IN THE MATTER OF THE	§	BEFORE THE STATE OFFICE
APPLICATION BY DIAMOND BACK	§	
RECYCLING AND SANITARY	§	OF
LANDFILL, LP FOR NEW MSW	§	
PERMIT NO. 2404	8	ADMINISTRATIVE HEARINGS

LAWRENCE G. DUNBAR, P.E.

Figure 3. Inflow Hydrograph for North Pond with Detention Storage Provided Filled Up

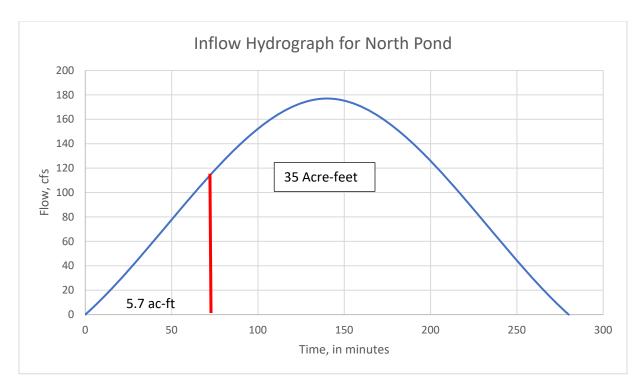
Drainage Area A - 103.9 acres

Peak flow (25-yr) - 177 cfs

25-yr, 24-hr rainfall - 4.75 inches (assume 85% becomes runoff from the landfill)

25-yr, 24-hr runoff - 4.0 inches (4.75" of rain x 85%) or 0.33 feet

Inflow Volume - 35 acre-feet (103.9 acres x 0.33 feet of runoff volume)

Detention Storage Capacity/Volume Provided - 5.7 acre-feet

Detention storage capacity/volume provided is used up in about 70 minutes, less than half of the time before the peak inflow of 177 cfs enters the filled up pond. This means that there is little detention being provided to reduce the peak inflow down to the existing conditions rate, such that this pond will discharge most of the peak inflow of 177 cfs, and not the 65 cfs reported by the Applicant.

Figure 4. Inflow Hydrograph for South Pond with Detention Storage Provided Filled Up

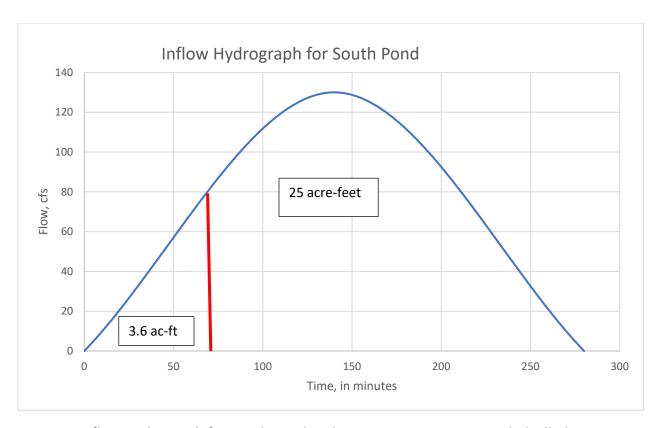
Drainage Area A - 75.6 acres

Peak flow (25-yr) - 130 cfs

25-yr, 24-hr rainfall - 4.75 inches (assume 85% becomes runoff from the landfill)

25-yr, 24-hr runoff - 4.0 inches (4.75" of rain x 85%) or 0.33 feet

Inflow Volume - 25 acre-feet (75.6 acres x 0.33 feet of runoff volume)

Detention Storage Capacity/Volume Provided - 3.6 acre-feet

Detention storage capacity/volume provided is used up in about 70 minutes, less than half of the time before the peak inflow of 130 cfs enters the filled up pond. This means that there is little detention being provided to reduce the peak inflow down to the existing conditions rate, such that this pond will discharge most of the peak inflow of 130 cfs, and not the 54 cfs reported by the Applicant.
